INALWAYS ELECTRONICS INC.

產品變更通知 Product Change Notice

No. 20240912

To:
Inalways P/N(華瑋/力瑋)料號 :0717-CS/0717-CW/0717-CL/0717-CQ
0717-CQ1/0717-CS1/0717-CS2/0717-CS3
0717-1-PS/0717-1-PW/0717-1-PL/0717-1-PQ
0717-1-PQ-A/0717-1-PQ-C/0717-1-PW-C/0717-1-PW-2C

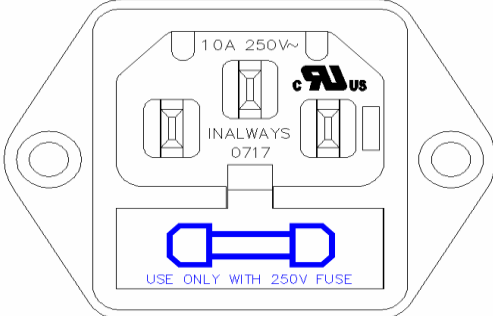
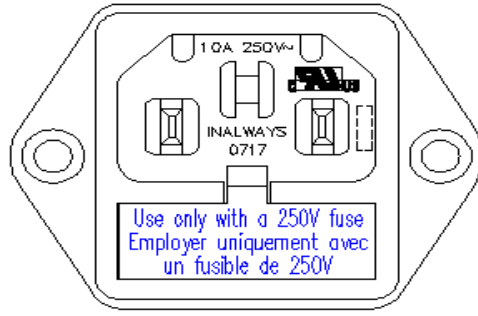
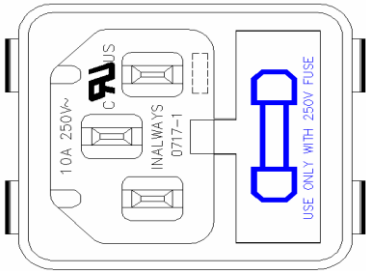
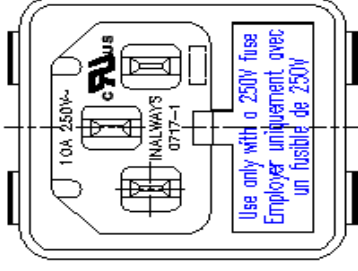
<p>Before (變更前):</p> <p>料号：0717-CS/0717-CW/0717-CL/0717-CQ 0717-CQ1/0717-CS1/0717-CS2/0717-CS3</p>  <p>The diagram shows a fuse holder with a blue fuse inserted. The text '10A 250V~' is at the top, 'cRUus' is on the right, and 'INALWAYS 0717' is in the center. At the bottom, it says 'USE ONLY WITH 250V FUSE'.</p>	<p>After(變更後):</p>  <p>The diagram shows the same fuse holder, but with a blue box at the bottom containing the text: 'Use only with a 250V fuse' and 'Employer uniquement avec un fusible de 250V'.</p>
<p>Before (變更前):</p> <p>料号：0717-1-PS/0717-1-PW/0717-1-PL/0717-1-PQ 0717-1-PQ-A/0717-1-PQ-C/0717-1-PW-C/0717-1-PW-2C</p>  <p>The diagram shows a fuse holder with a blue fuse inserted. The text '10A 250V~' is on the left, 'cRUus' is at the top, and 'INALWAYS 0717-1' is in the center. At the bottom, it says 'USE ONLY WITH 250V FUSE'.</p>	<p>After(變更後):</p>  <p>The diagram shows the same fuse holder, but with a blue box at the bottom containing the text: 'Use only with a 250V fuse' and 'Employer uniquement avec un fusible de 250V'.</p>

- UL/CUL標準升級，CSA要求保險絲座刻字需同時包含英文及法文。
UL / CUL standard upgrade, CSA requires fuse holder inscription to include both English and French。
- 變更後的圖紙如附件
The drawings are as attached files.
- 變更刻字後的出貨將於 2025/02/05
The marking changes shipment will be started from 2025/02/05
